Limited Energy Study of Hangar Facilities at Simmons Army Airfield (SAAF), Fort Bragg, North Carolina

Final Report

Savannah District-
US Army Corps
of Engineers

*RESPONSE TO
INTERIM REVIEW COMMENTS*

Figure 1
GAS
DISTRIBUTION PLAN

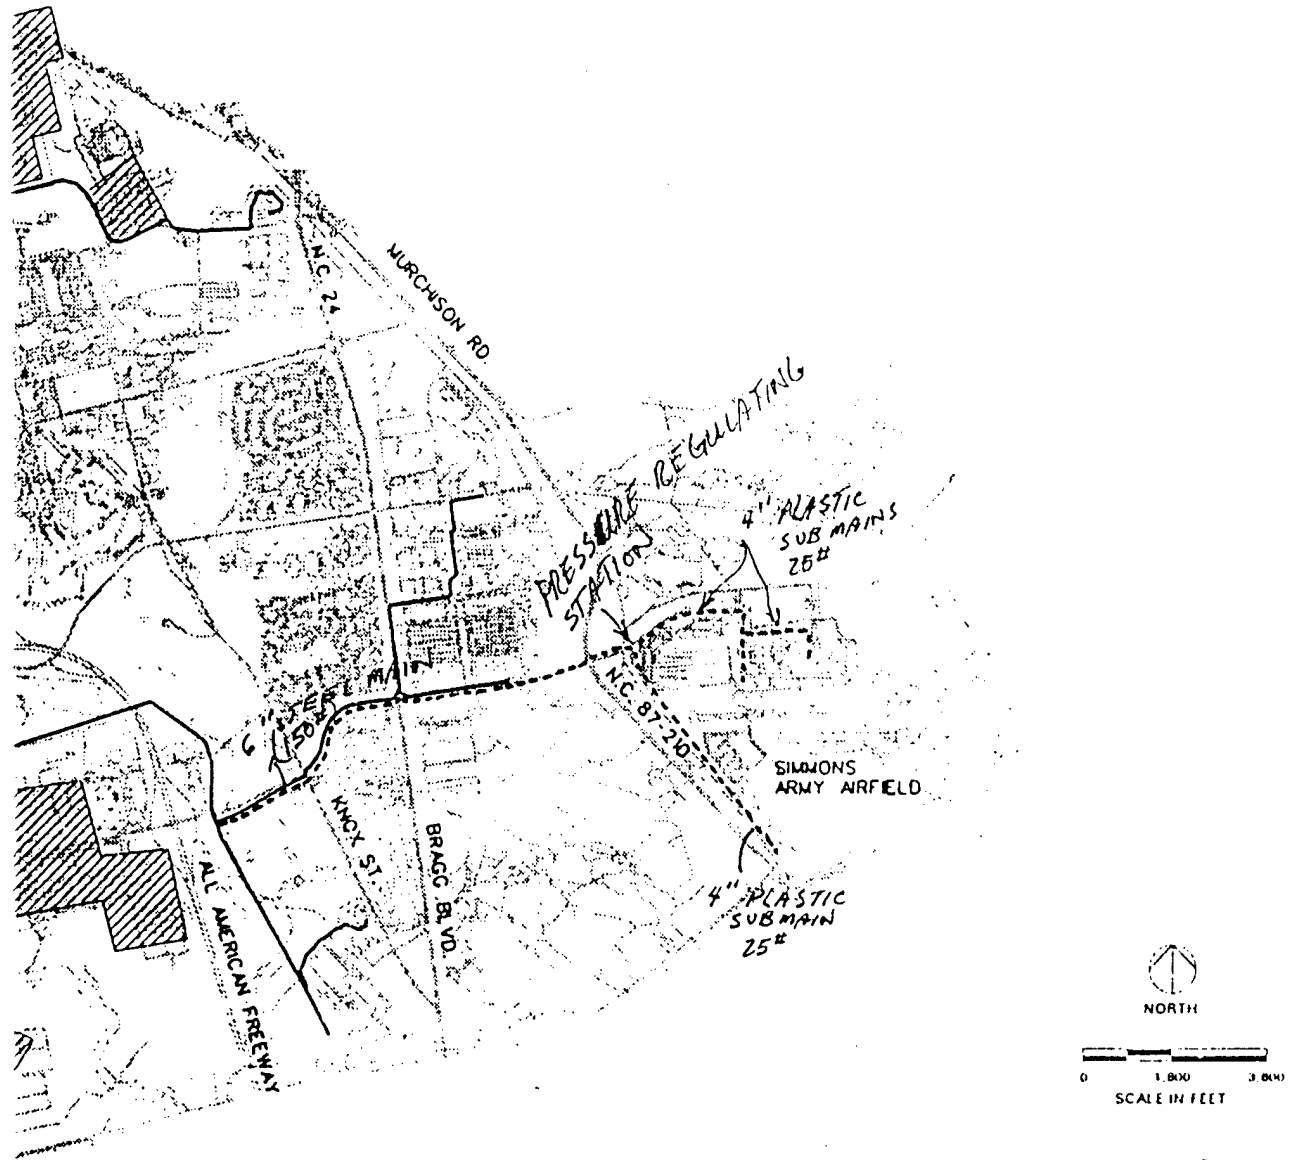
Comment No.	Vol.	Sec.	Page	COMMENTS <small><input type="checkbox"/> Struc. <input type="checkbox"/> Arch. <input type="checkbox"/> Civ. <input type="checkbox"/> Mech. <input type="checkbox"/> Elec. <input type="checkbox"/> San. <input type="checkbox"/> Env. <input type="checkbox"/> Fire <input type="checkbox"/> Other</small>	Action Code	RESOLUTIONS (include location of documents)	Ref.
1	2	8	4	Costs for pressure testing, overhead, bond, and subcontracting need to be added to cost estimate.	A	Costs have been added to cost estimates.	
2	2	8	4	Sixty psi, 4" line is stated. The gas company states that high pressure (150 psi), steel 6" line should be used to transport that distance.	A	Cost estimates have been revised to incorporate recommended changes by NCNG.	
3	--	--	--	A map showing the proposed gas line routing and distribution is needed.	A	Map has been included in Final submittal. See Section 5.3.2.
